Type Coffee Vending Machine	Model 9XXX	N° T.I. 01 - 2022
Serial Number 20220429	Subject NEW ESPRESSO VALVE ASSEMBLY WITH RESTRICTOR	ISSUED FOR (X) Action Information X

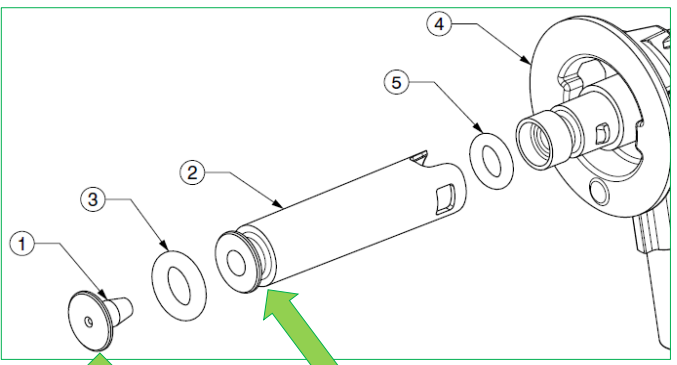
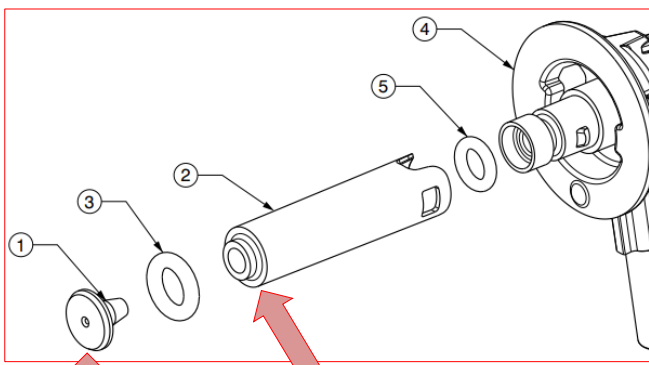
Be informed that, with the aim to prevent the restrictor coming off the valve body, the *Espresso valve assembly* has been modified as follow

Pre-modification
Spare code: **262038**

NEW
Spare code: **265029**
From SN: **20220429**

Spare code	Description	Note
262038	ES valve assembly with restrictor	no more available
265029	ES valve assembly with restrictor - NEW!	Available!
979291	Kit "ES Valve-Nozzle" (JDE SAP number 55123711)	Available! with new ES valve assembly. The kit code remains the same
